Ginna Station

UFSAR Section 6.2.4 and Tables 6.2-13, 6.2-14 and 6.2-15 Changes

NSL-0000-SA024

Revision 3

Figure 6.2-13
S/G Inspection/Maintenance,
~~Penetration No. 2~~
Fuel Transfer Tube, Penetration No. 29

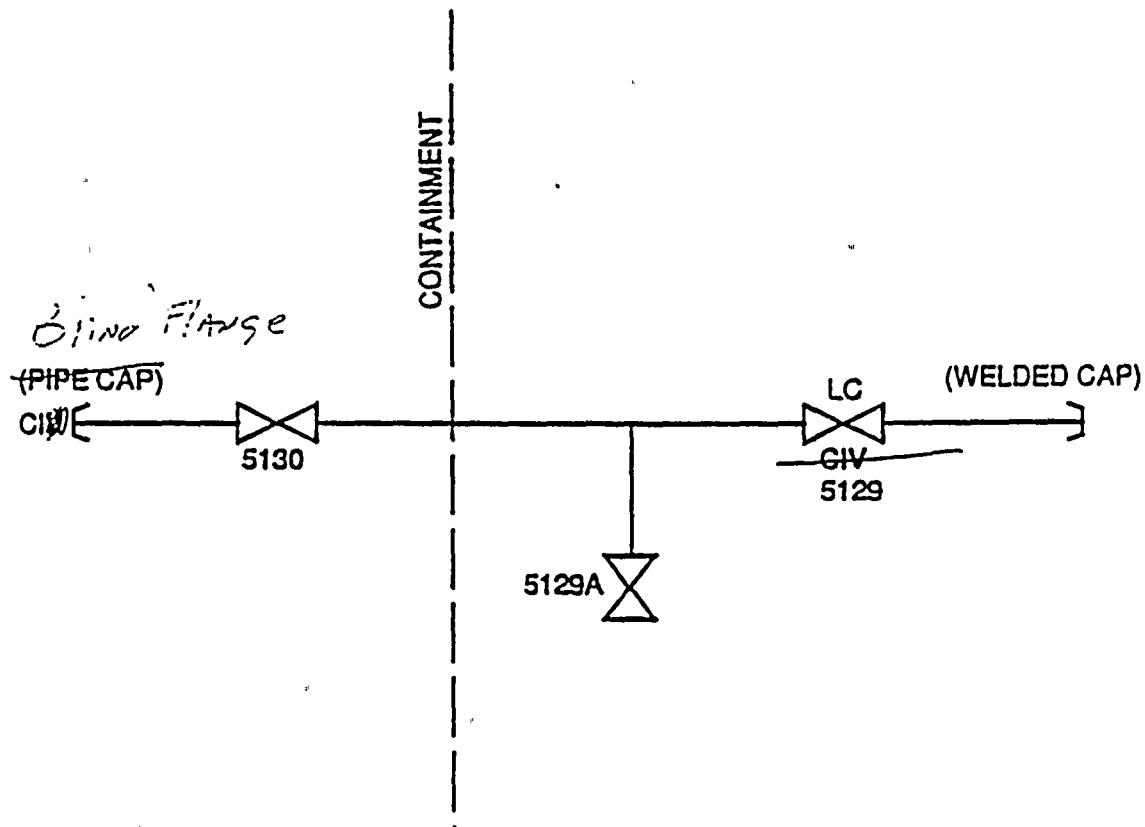
- 3.3.2 The updates to the UFSAR table to better represent actual plant conditions are described below.
- 3.3.2.1 Penetration #2 was added to the table. This spare penetration was modified during the 1990 Refueling Outage to enhance containment closure during mid-loop operations. The penetration meets all current containment penetration criteria. See Reference 2.17.

- (1) Penetration number 2 was added as a result of EWR 4998 to facilitate steam generator maintenance activities during reduced inventory operation. This penetration is closed by a double-gasketed on both ends; however, only one of the two flanges is necessary for containment integrity purposes.

No.	Change	Effect
1.	Penetration 2 - Added penetration and necessary information to the table.	This spare penetration was modified to provide access for steam generator inspection and maintenance cabling during refueling outages to enhance containment closure during midloop operations. No new valves were added.

Figure 6.2-17
Construction Fire Service Water
Penetration No. 103

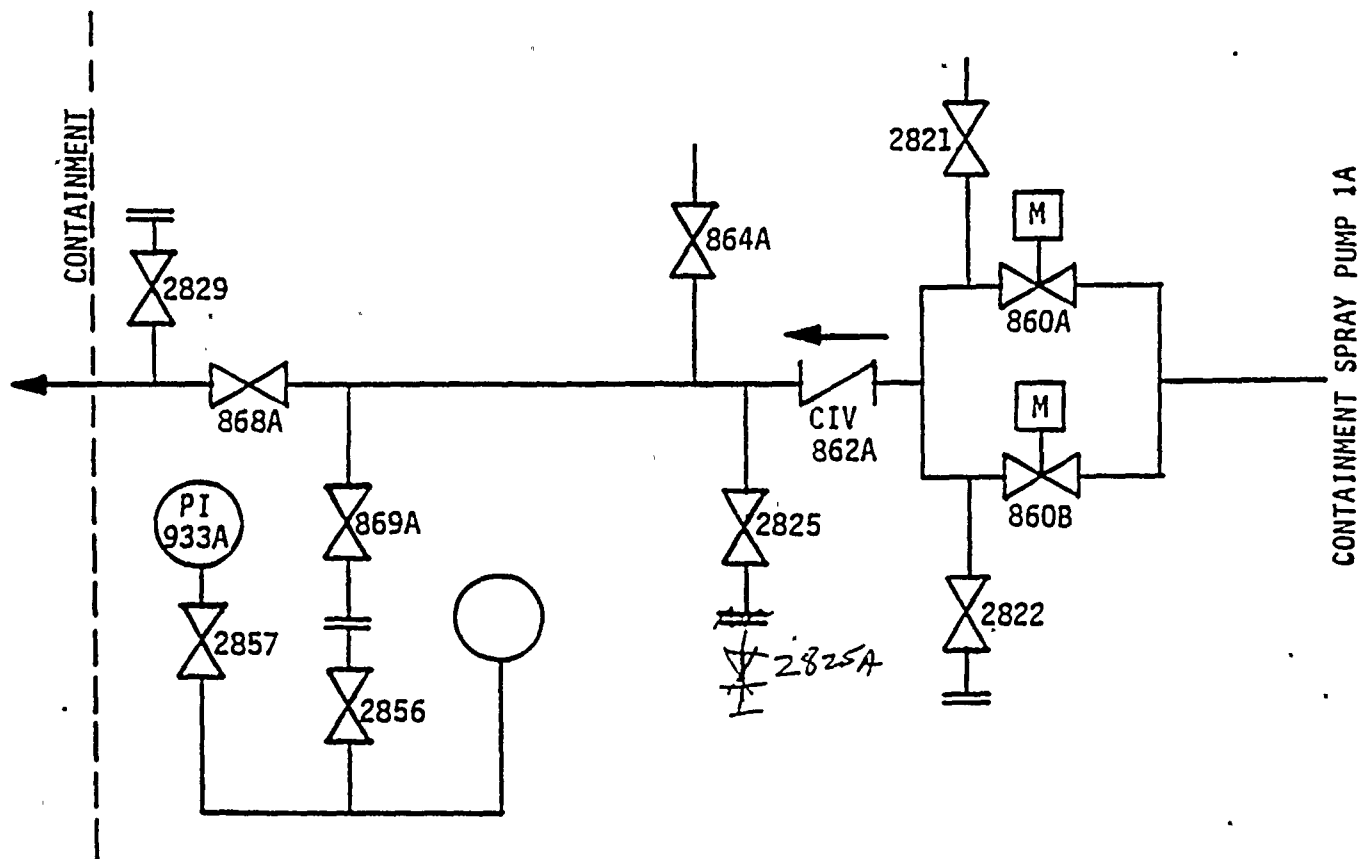
- (a) Penetration 103 - Valve 5129 was deleted from the table and replaced by a Blind Flange. This change enabled the elimination of the previous note of "No longer in use" that was associated with this penetration. The penetration now reflects the current configuration. The use of the Blind Flange is consistent with the previous locked-closed manual valve.

5.	Penetration 102 - (1) Global Notes 1, 2, 4, and 5; (2) Added Note 4.	(1) (2) No technical change.
6.	Penetration 103 - Deleted valve 5129 (entire line in table) and replaced with Blind Flange.	Replaced Note of "No longer in use" to reflect accurate configuration status of Blind Flange. The use of the Blind Flange is consistent with the previously listed locked-closed manual valve.

Figure 6.2-18
Containment Spray Pump 1A
Penetration No. 105

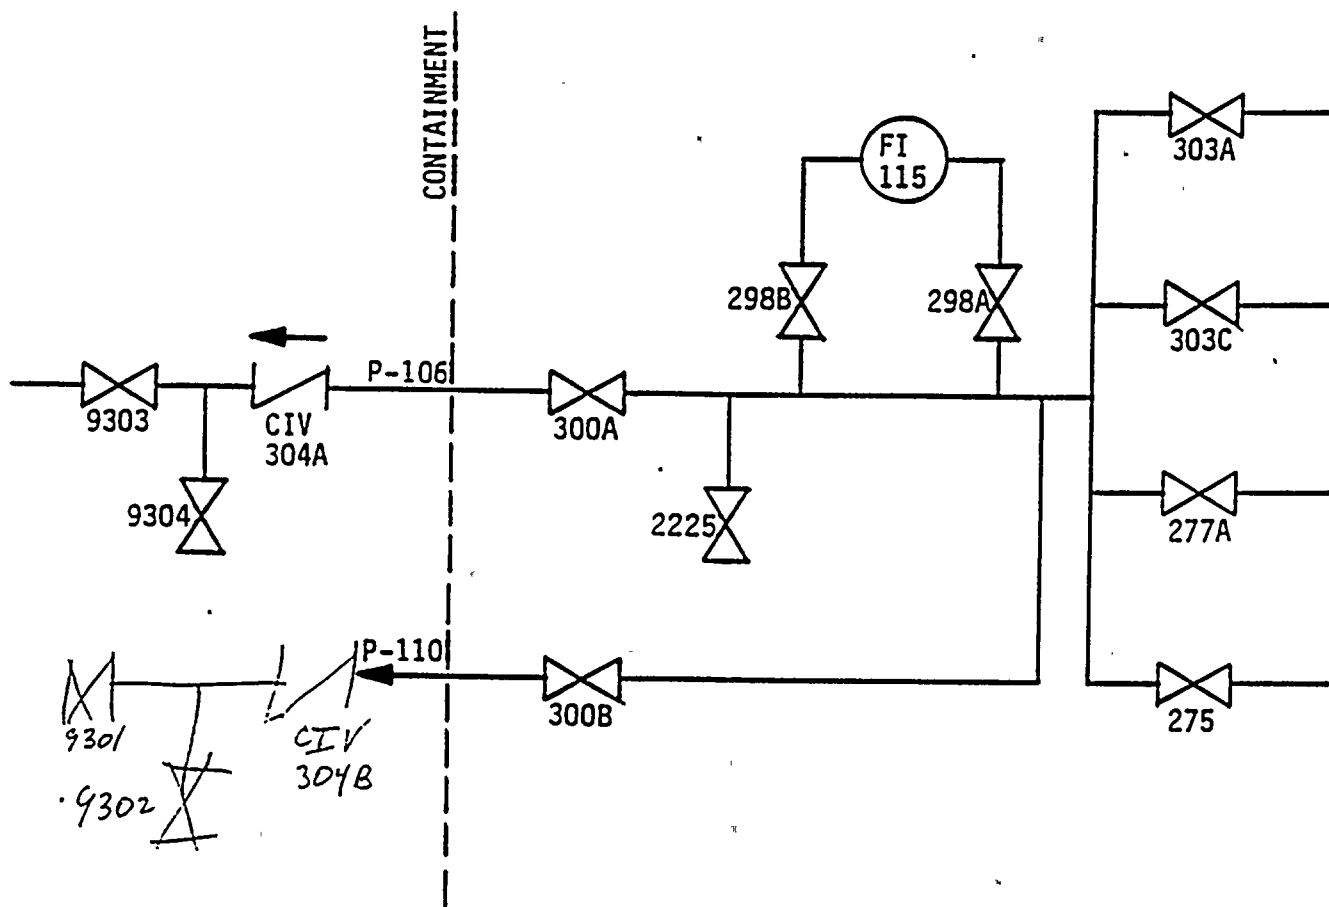
No.	Change	Effect
7.	Penetration 105 - (1) Global Notes 1, 2, and 4; (2) Added Note 4.	(1) (2) No technical change.
8.	Penetration 106 - (1) Global Notes 1, 2, and 4; (2) Added Note 4; (3) Changed "supply" to "Inlet" under <u>System</u> .	(1) (2) No technical change. (3) Minor clarification only. No technical change.

Figure 6.2-22

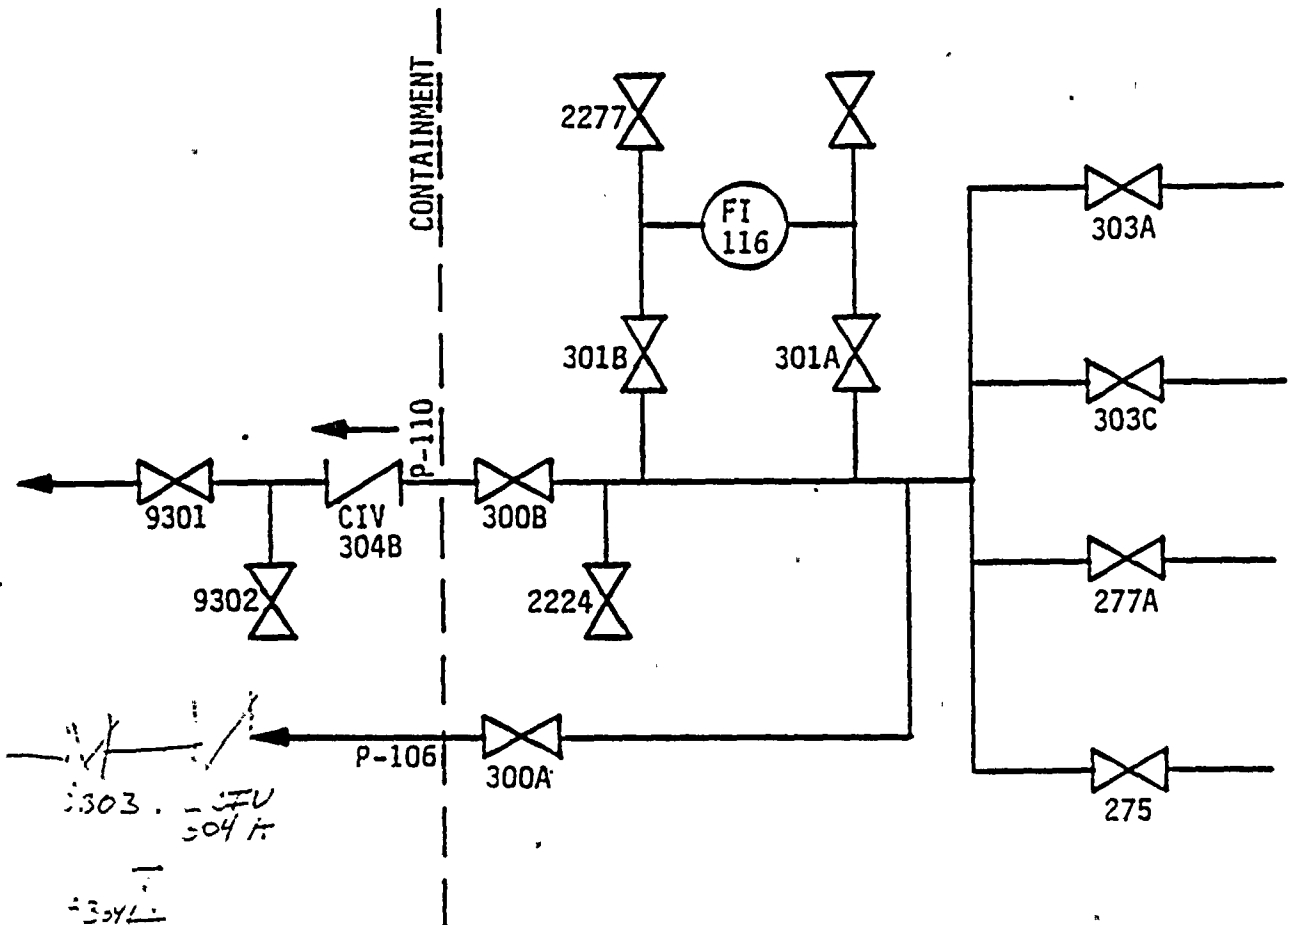
11.	Penetration 109 - (1) Global Notes 1, 2, and 4; (2) Added Note 4.	(1) (2) No technical change.
12.	Penetration 110a - (1) Global Notes 1, 2, and 4; (2) Added Note 4.	(1) (2) No technical change.

Figure 6.2-24

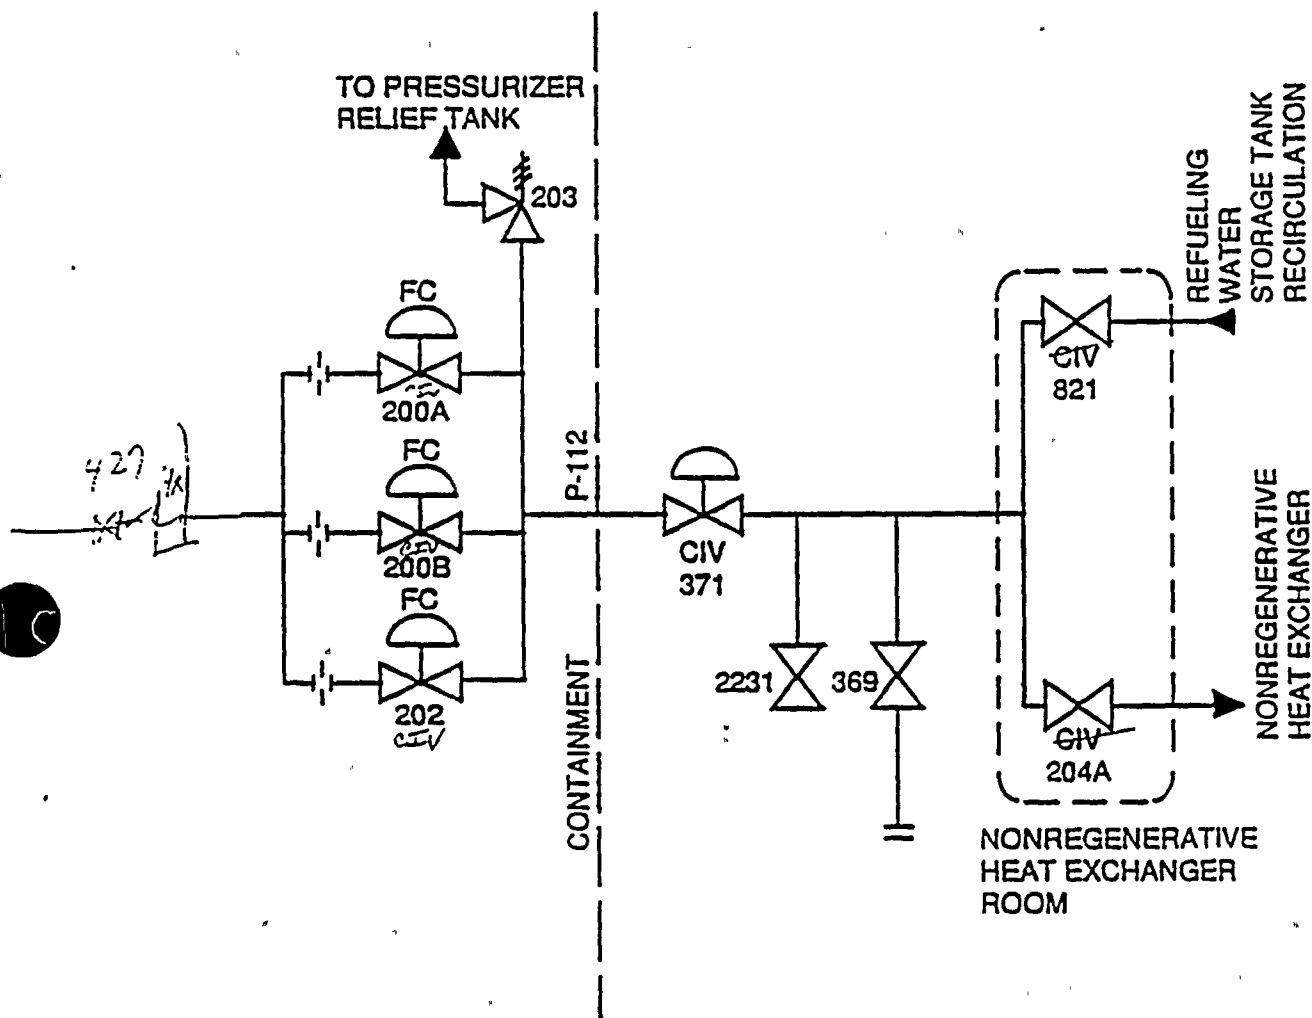
- (b) Penetration 111 - Added valve 959. The addition of this valve to the table ensures that all valves receiving a containment isolation signal are listed. This valve was previously missing from the table, but credit was not taken for the valve during the SEP (see Reference 2.7). Consequently, this is not considered an actual isolation valve and is not tested per Appendix J.

Section 6.2.4.4.4.2 - The discussion concerning line 111 was revised to show that only one motor-operated valve is provided for this penetration instead of the two previously listed. The basis for this change is the same as discussed in Section 3.4.1.

14.	Penetration 111 - (1) Added Note 7 to both valves; (2) Added Note 8 to valve 720; (3) Added Note 4 to both valves; (4) Changed <u>Position Indication In Control Room</u> from "Yes" to "R/G" for MOV 720; (5) Added valve 959 and necessary information.	(1) Consistency with Technical Specifications. (2) (3) No technical change. (4) Minor clarification only. No technical change. (5) Valve receives containment isolation signal and was previously missing from the table.

Figure 6.2-31
Containment Pressure Sensing
Transmitters, Penetration Nos. 121c
and 121d

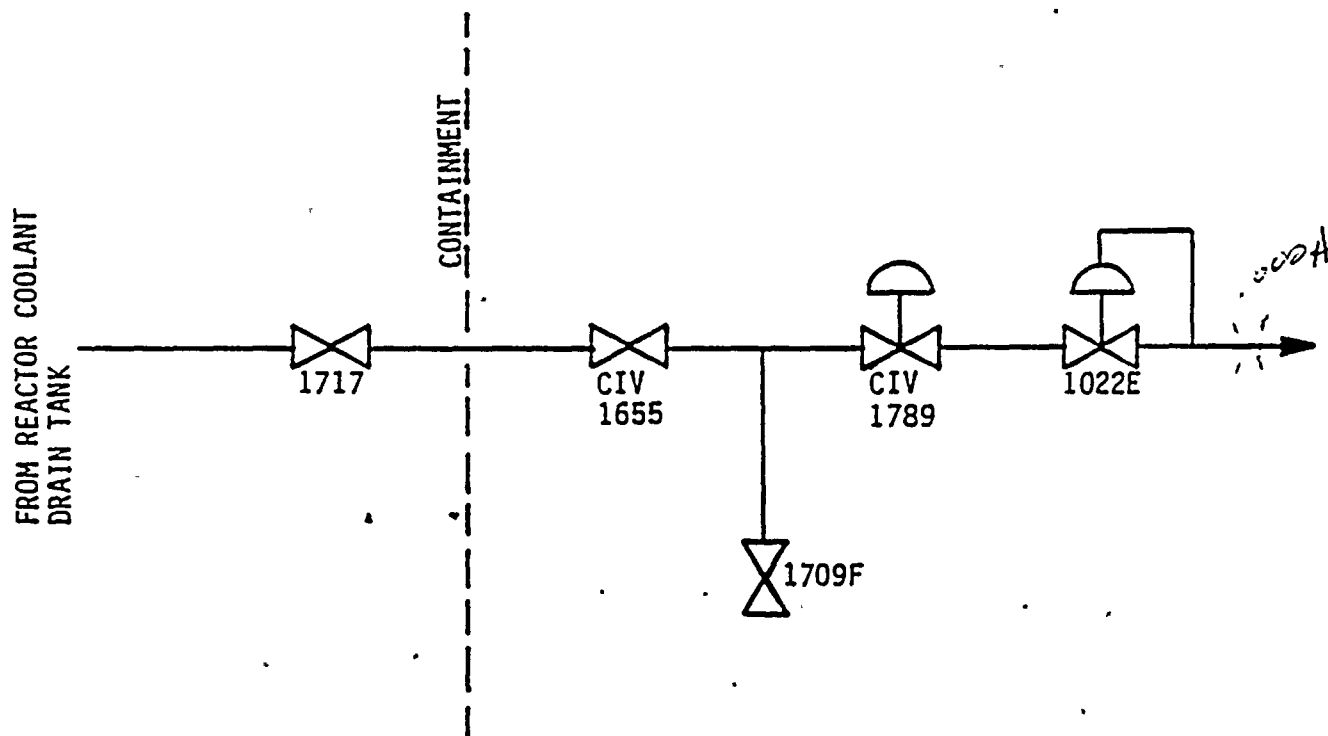
22.	Penetration 121c - (1) Global Note 1 for PT945; (2) Global Notes 3 and 4 for valve 1819A; (3) Added "Gate" under <u>Valve Type</u> for valve 1819A.	(1) (2) No technical change. (3) Correction of typographical omission. No technical change.

23.	Penetration 121d - (1) Global Note 1 for PT946; (2) Global Notes 3 and 4 for valve 1819B.	(1) (2) No technical change.
24.	Penetration 123 (bottom) - (1) Added "to" before "Gas Analyzer Line" under <u>System</u> ; (2) Global Notes 3 and 4 for 1655; (3) Changed valve 1789 from "Globe" to "Diaphragm"; (4) Changed <u>Position Indication In Control Room</u> from "Yes" to "Status" for valve 1789; (5) Changed <u>Position At Normal Operation</u> from "O/C" to "O" for valve 1789; (6) Added valve 1600A; (7) Reordered penetration valves.	(1) Consistency with Technical Specification Table 3.6-1. (2) No technical change. (3) Correction of typographical error. No technical change. (4) Minor clarification only. No technical change. (5) Update for better representation of system configuration since this line remains open. (6) Valve receives containment isolation signal and was previously missing from the table. (7) Valves now in numeric order. No technical change.

Figure 6.2-33

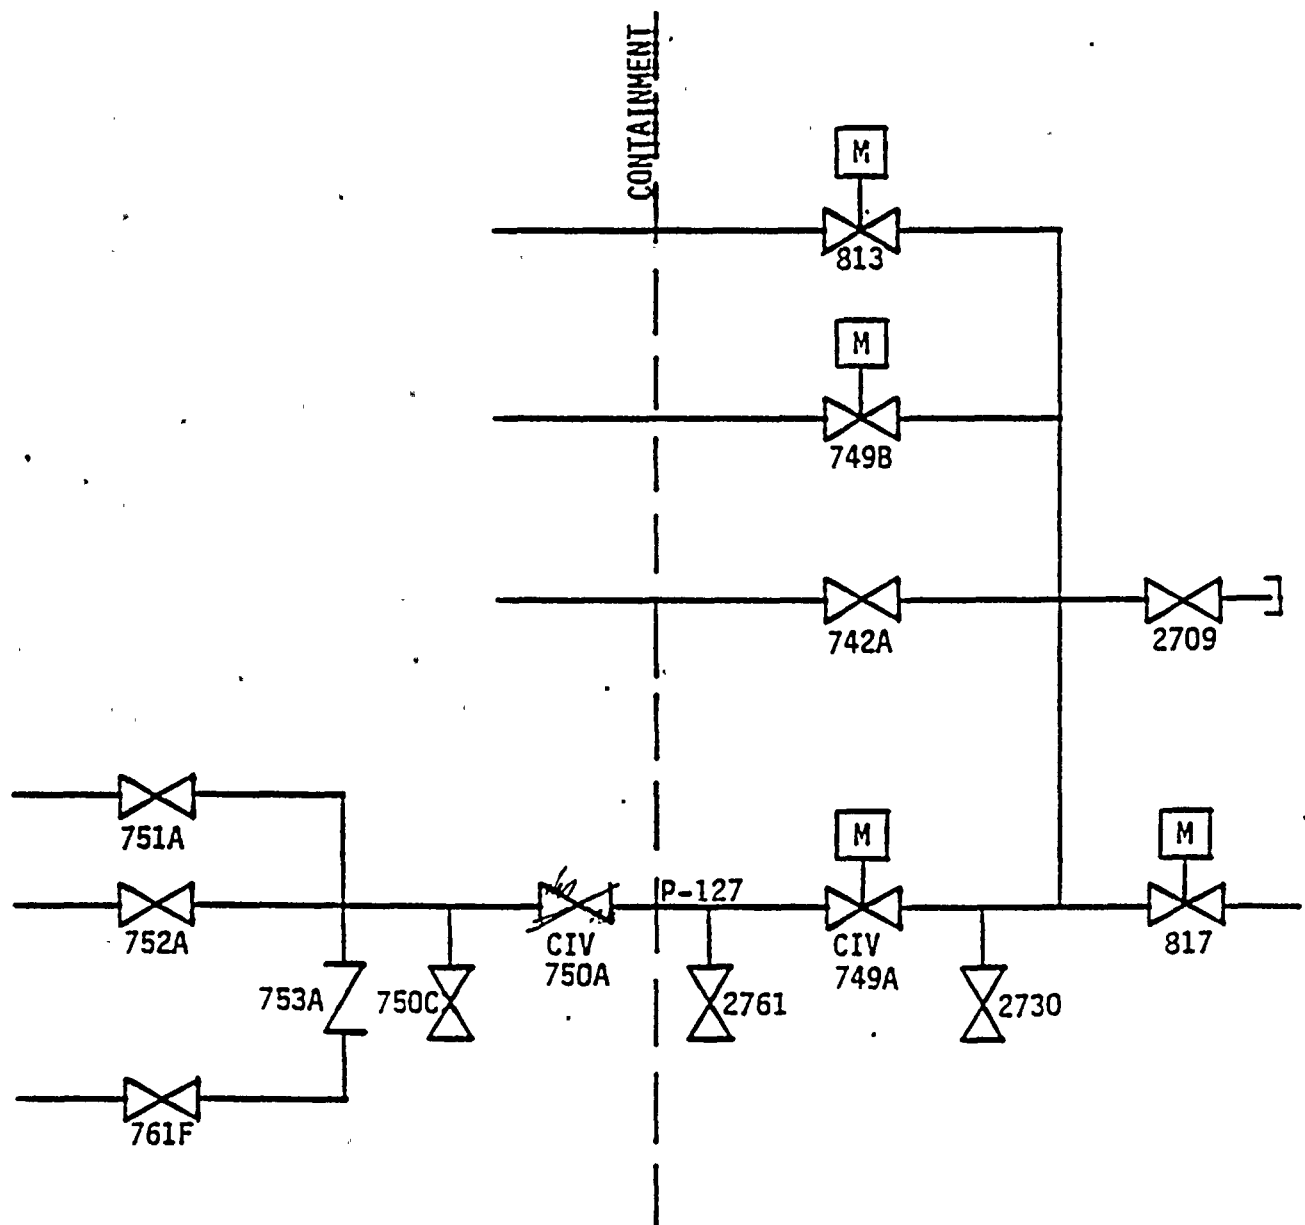
26.	Penetration 124a - (1) Global Notes 1, 2, and 4 for valve 743; (2) Changed <u>Position At Immediate Postaccident</u> from "O" to "C" for valve 743; (3) Changed <u>Position Indication In Control Room</u> from "Yes" to "R/G" for valve 745; (4) Changed <u>Trip on CIS</u> from "Yes" to "No" for valve 745; (5) Changed <u>Maximum Isolation Time</u> from "60" to "NA" for valve 745; (6) Changed <u>Position At Cold Shutdown</u> from "O" to "C" for valve 745.	(1) No technical change. (2) Update for better representation of system configuration. Operations is instructed to manually isolate this line following receipt of a containment isolation signal. (3) Minor clarification only. No technical change. (4) (5) Correction of typographical error. See letter from R. Mecredy, RG&E, to A. Johnson, NRC, dated July 9, 1990. (6) Update for better representation of system configuration since excess letdown is not operational during cold shutdown conditions.
